UNITED STATES PATENT AND TRADEMARK OFFICE

APPLICATION NO.	FILING DATE	FIRST NAMED INVENTOR	ATTORNEY DOCKET NO.	CONFIRMATION NO.
09/681,403	03/29/2001	Tore Fosse	VCC0082-US	3278

# Office Action Summary

**FIG. 1**

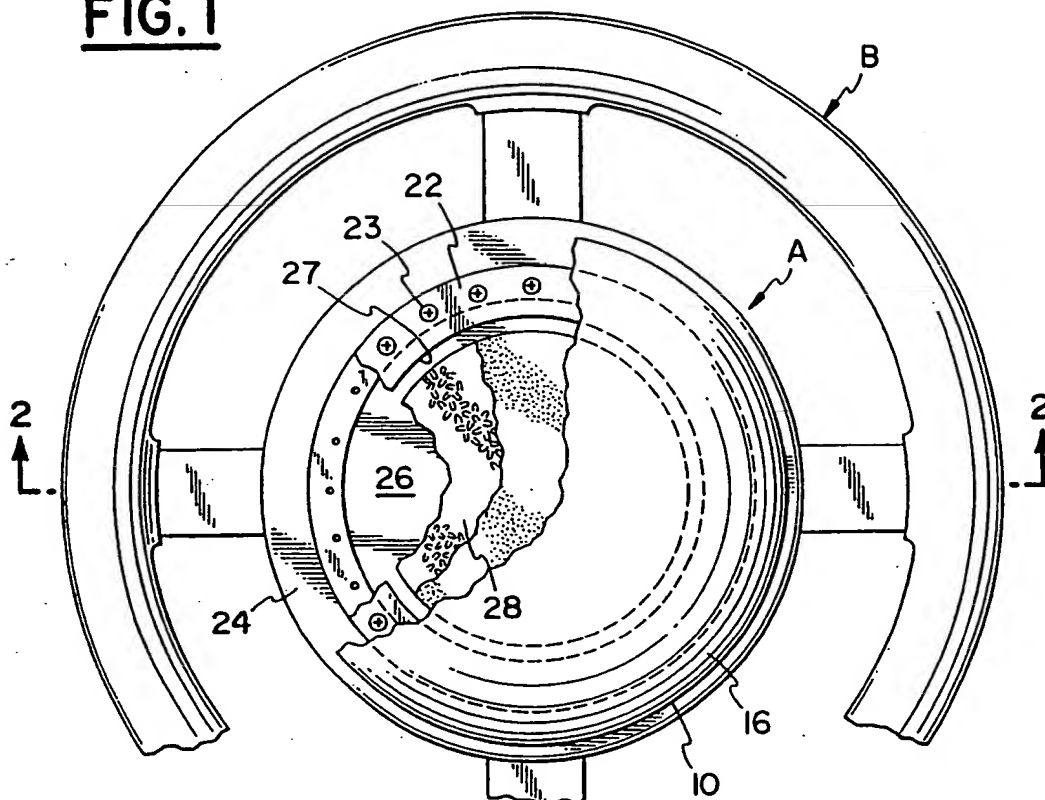
Claims 1 – 26 are rejected under 35 U.S.C. 102(b) as being anticipated by Young (US 5,480,184). Young discloses a hub (see Fig. 2) for fixing to a steering column (S in Fig. 2), a substantially conical bowl-shaped element (see Fig. 2) connected to the hub with at least one

spoke (see Figs. 1, 2), the spoke further connecting the bowl-shaped element to a steering wheel rim (B in Fig. 1, 2), wherein the hub, bowl-shaped element, and at least one spoke are integrally formed as a single material item (see Fig. 2), the bowl-shaped element further comprising an upper shell part (24 in Fig. 2) and lower shell part (see area near 19 in Fig. 2), the upper shell part having larger outer dimensions than the lower shell part and the shell parts being connected by a ledge extending substantially in the radial direction relative to the longitudinal axis of the steering column (see Fig. 2), the bowl-shaped element also comprising a casing for enclosing an airbag and means for inflating the airbag (18 in Fig. 2), where a wall section of the bowl-shaped element at least partly forms part of the means for inflating the airbag (see area, attachment at 19 in Fig. 2).
